**WARRANTY
BULLETIN**

Wb99-04

DATE : JANUARY 1999	SECTION : 23 - Accessories
EXPIRATION: JANUARY 2000	
SUBJECT : LAVATORY DRAIN PIPE REPLACEMENT

Model	VIN
H3-41 and H3-45 Coaches Model Year : 1996 - 1999	From 2PCH33493I1011572 up to 2PCH33491X1012970 incl.

FIGURE 2: DRAIN PIPE (BEFORE MODIFICATION)

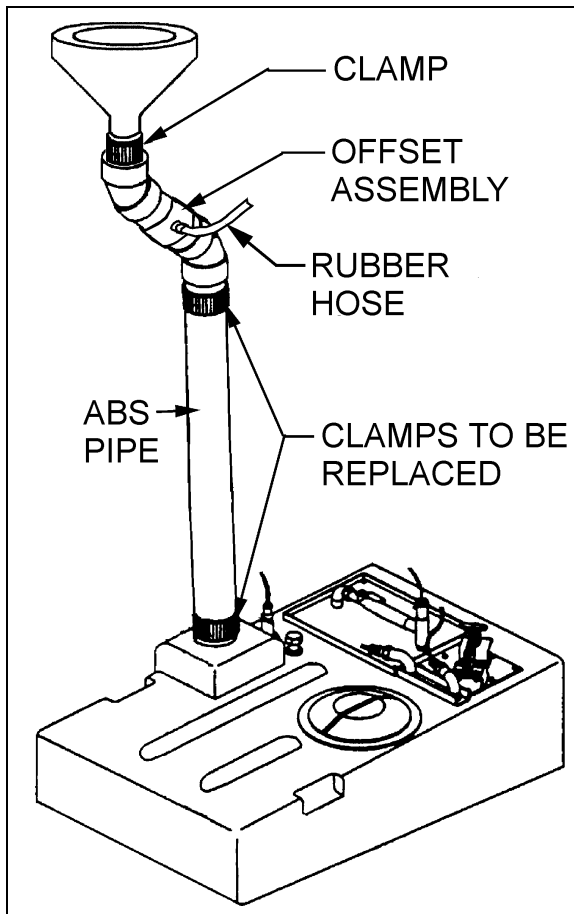
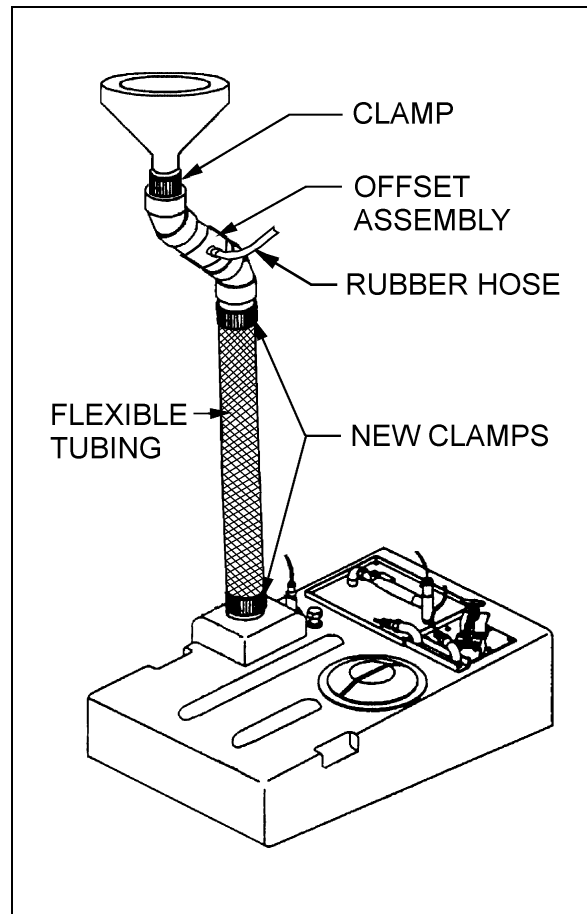
On the above-mentioned vehicles, drain pipe rigidity of mounting may cause offset assembly to crack. Replacement of rigid ABS pipe with flexible tubing prevents this situation from happening.

3. Unfasten rubber hose clamp screw as well as clamp securing offset assembly to toilet bowl sleeve.
4. Open engine compartment rear door and engine compartment R.H. side door. Unfasten ABS pipe clamp screws, remove clamps and ABS pipe as well as offset assembly (refer to figure 2).
5. Install new offset assembly to toilet bowl sleeve and secure using clamp. Fix also rubber hose clamp. Install flexible tubing (Prévost #402418) together with new clamps (Prévost #504235).
6. Perform drain pipe test to ensure no leaks are present. Tighten clamp screws as needed.

1. Open engine compartment rear door and engine compartment R.H. side door. Unfasten ABS pipe clamp screws, remove clamps and ABS pipe (refer to figure 2 and 3).
2. Install flexible tubing (Prévost #402418) together with new clamps (Prévost #504235).
3. Perform drain pipe test to ensure no leaks are present. Tighten clamp screws as needed.
